City of Tucker

Land Use Petition: RZ-19-0005

Date of Staff Recommendation Preparation: October 16, 2019

STAFF RECOMMENDATION:	Approval with modifications to incorporate staff recommended alternative(s).

Zoning Map.

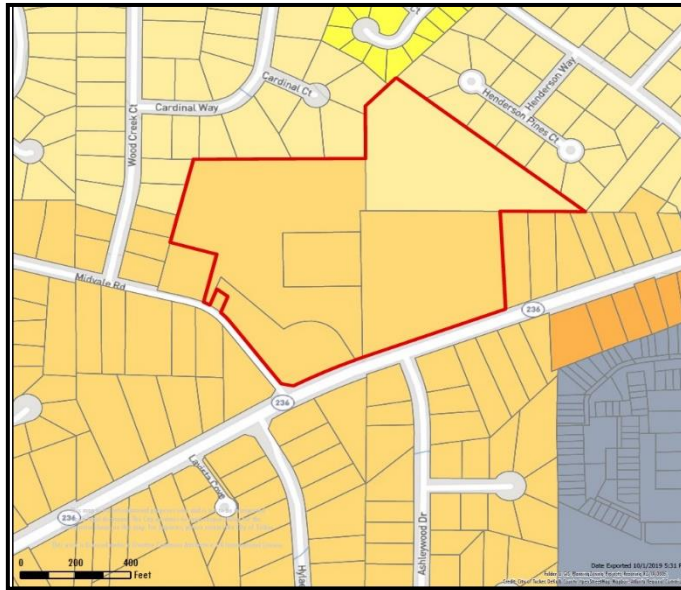
The site (delineated with stars) is surrounded by single-family homes. To the northeast is the Henderson Trails subdivision (zoned R-100); due north is a R-60 subdivision “Thawley Place” submitted in 1987 (Case

CZ-87041) and approved by DeKalb County. Immediately to the northwest is the Cardinal Woods subdivision (zoned R-100). South across Lavista Road is the Ashleywoods Manor subdivision.
